SERVICE BULLETIN

M-1305

Transmission Bearing Housing and Oil Pan Torque Specification Changes

Figure 1. Transmission Bearing Housing Screws

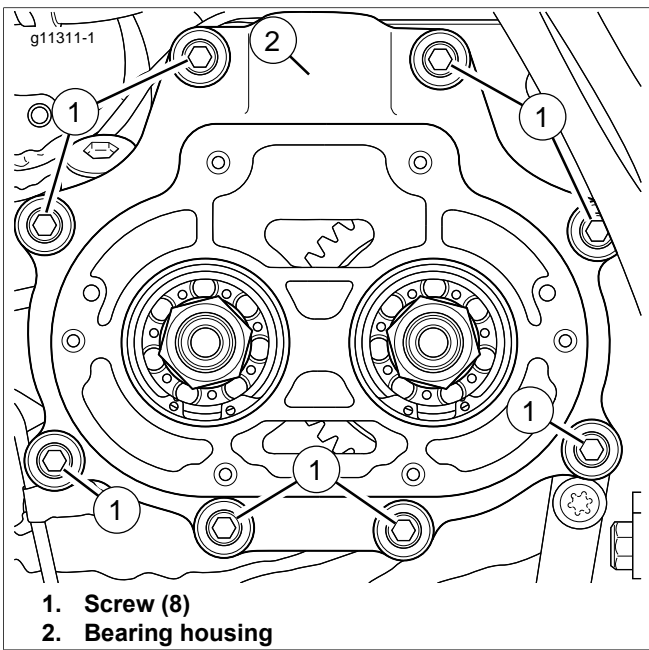
Update all affected service manuals with the following torque changes. Torque sequences remain unchanged.

FIGURE	YEAR	MODEL	FASTENER	TORQUE
Figure 1	2006-2012	Dyna	Transmission bearing housing screws	23-25 ft-lbs (31.2-33.9 Nm)
Figure 1	2007-2012	Softail	Transmission bearing housing screws	23-25 ft-lbs (31.2-33.9 Nm)
Figure 1	2007-2012	Touring	Transmission bearing housing screws	23-25 ft-lbs (31.2-33.9 Nm)
Figure 2	2006-2012	Dyna	Oil pan screws	132-156 in-lbs (14.9-17.6 Nm)
Figure 2	2007-2012	Touring	Oil pan screws	132-156 in-lbs (14.9-17.6 Nm)
